FINAL INITIAL STUDY/ MITIGATED NEGATIVE DECLARATION

MITIGATION MONITORING AND REPORTING PROGRAM, RESPONSE TO COMMENTS, AND ERRATA

WEST ANTELOPE SOLAR ENERGY PROJECT, UNINCORPORATED LOS ANGELES COUNTY, CALIFORNIA

PROJECT NO. R2012-01589-(5)
CONDITIONAL USE PERMIT NO. 201200086
ENVIRONMENTAL ASSESSMENT NO. 201200158
SCH NO. 2013101055

Figure 1: Maximum daily NOx emissions in lbs/day during construction of the Project

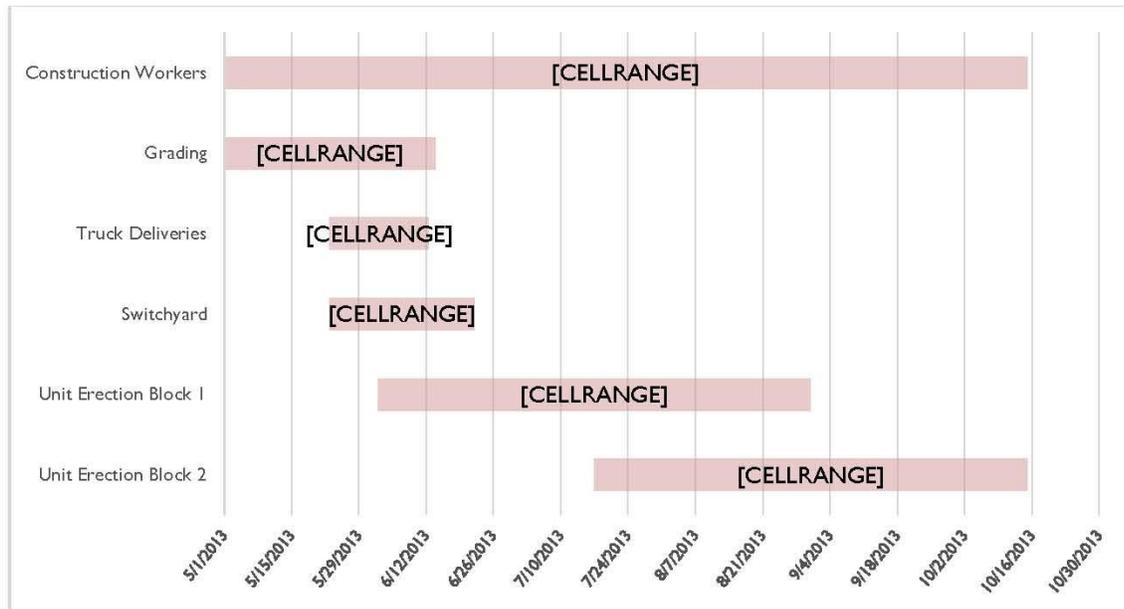
Figure 1 below shows the timeline of Project construction and summarizes maximum daily emissions of nitrogen oxides (“NOx”) in pounds per day (“lbs/day”) occurring during each construction phase and from construction commuter vehicles based on information provided in the IS/MND.

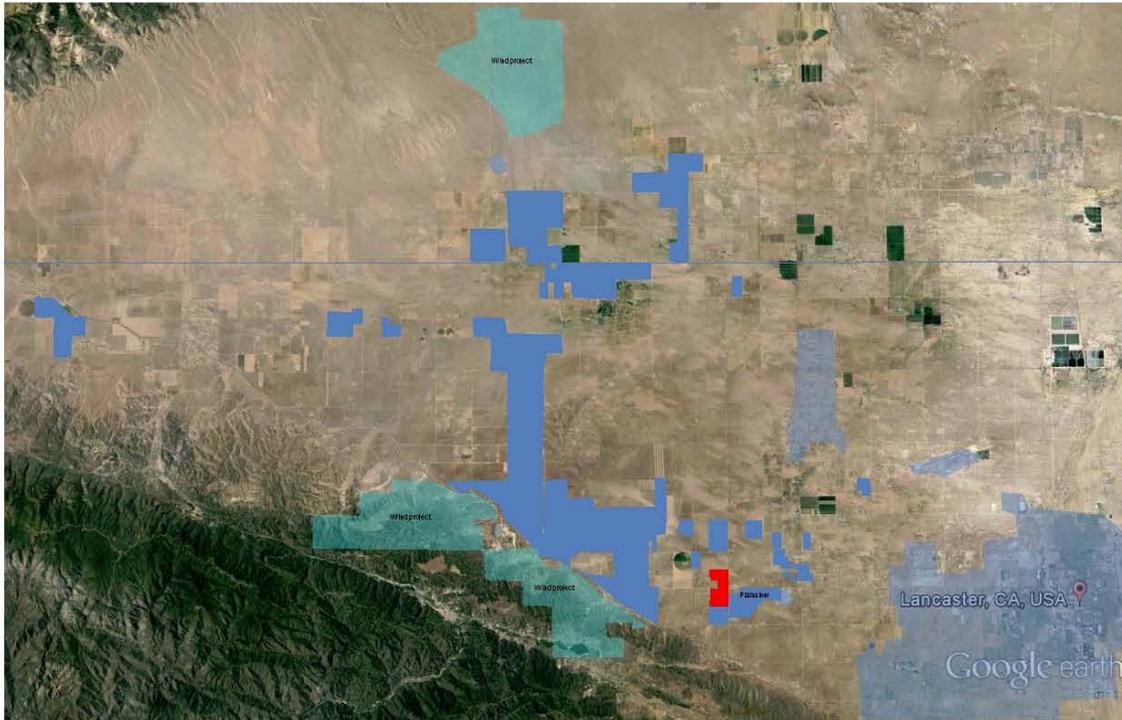
That the project will interfere with wildlife movement should be obvious, given the extent of planned an ongoing solar and wind projects in the region (Figure 1). Planned and ongoing solar projects, including the West Antelope Solar Energy Project, nearly extend the entire north-south distance of the Antelope Valley, thereby cutting off east-west movement of terrestrial wildlife (Figure 1). Such an outcome will prove devastating to wildlife in the area.

Habitat fragmentation is a process that is central to a project's impacts on wildlife movement. It is recognized as one of the most serious threats to the continued existence of terrestrial wildlife (Wilcox and Murphy 1985). BonTerra Consulting (2013) provided analysis of habitat fragmentation. Figure 1 illustrates that an analysis of habitat fragmentation is warranted.

The Neg Dec failed to provide a serious cumulative impact assessment on biological resources. This region has been targeted by energy companies for the development of at least 38,236 acres (4,803 MW) of solar projects (Figure 1). Immediately adjacent to the east is the Plainview Solar Works project, and to the south is another project. Not far to the west is a long, north-south reach of multiple solar projects. As discussed earlier, the Plainville Solar Works project will displace burrowing owls. If these owls lack opportunities to relocate, such as to the West Antelope Solar project, then the cumulative impacts will be substantial and very significant. The same result will hold for many other special-status species.
